CHANGES FROM BASE PRODUCT VBV- L4025 (1554) TO AC-068 (5234)

Assembly Pl Approval S. ATTWOOD 06/12/2016	Approved by B. CHILDS	Checked by D. RICHARDSON	Drawn by M.Sale
Angle of Projection 	Units mm	Scale N/A	Released 06/12/16
Status RELEASED	AC-068		
Part No 5234	BE-003499-00-16

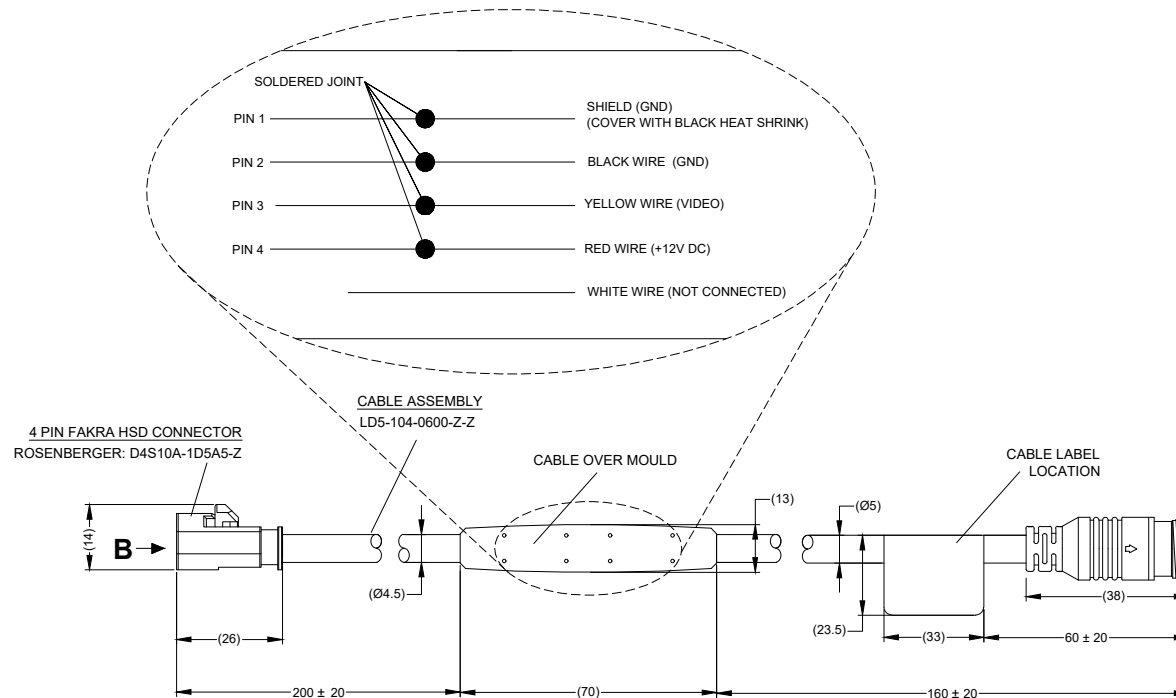
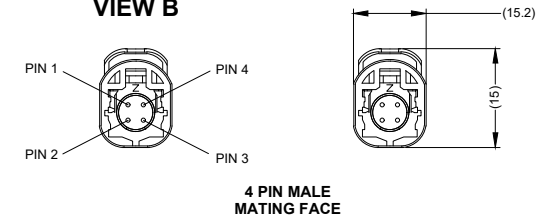
- CHANGE:
1. REPLACE 4 PIN FEMALE VBV CONNECTOR WITH OVER MOULDED CABLE ASSEMBLY
 2. VBVL4025 CB-LBL TO BE REPLACED BY AC-068 (5234) CB-LBL
 3. VBV L4025 GB-LBL REPLACED BY AC-068(5234) GB-LBL
 4. AC-068-IG(5240) ADDED
